ITEM 5.A.
OAKBROOK CENTER
Restoration Hardware – Planned Development

STAFF REPORT

CASE FILE NO: 2019-12-ZO-PUD

Brookfield Oak Brook RH Planned Development – Staff Comments and Project Team Responses 10-11-2019

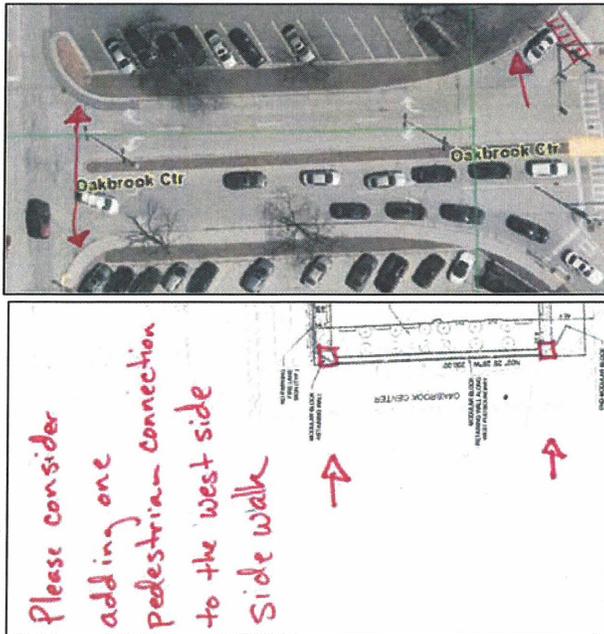
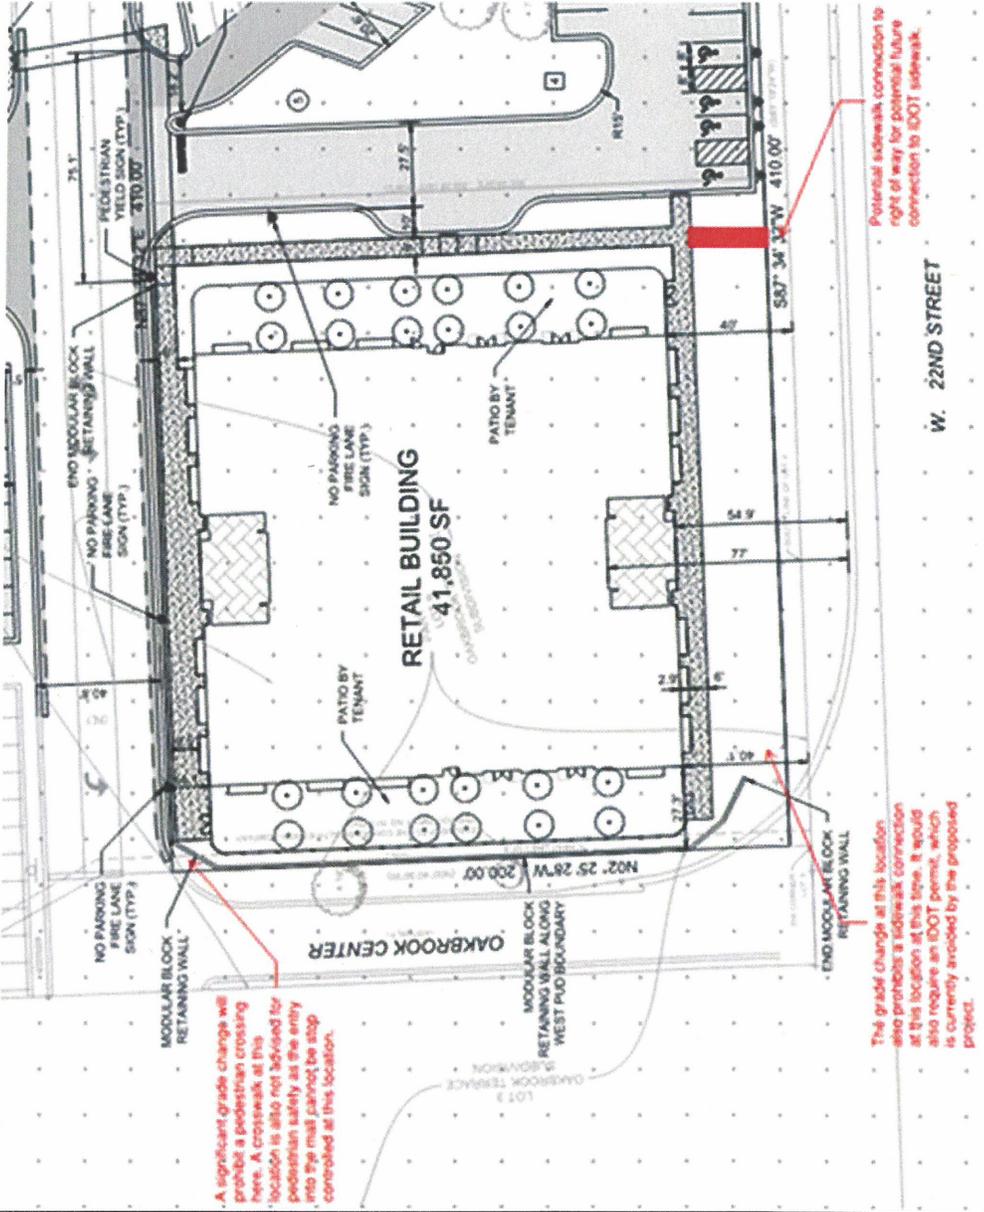
From Rebecca Von Drasek (10/9/2019) “Since there is a sidewalk on the west side, staff felt that a connection from the curb to the RH sidewalk would make traversing this area on foot easier.”

Unfortunately, grade changes make pedestrian connections at both locations problematic. We're also concerned pedestrian safety would be jeopardized without stop signs for entering and northbound cars at these locations, which could seriously risk traffic back-ups on 22nd Street. For long-term planning, though, a potential location for additional pedestrian connection would be the Southeast corner of the Gallery, as shown below.
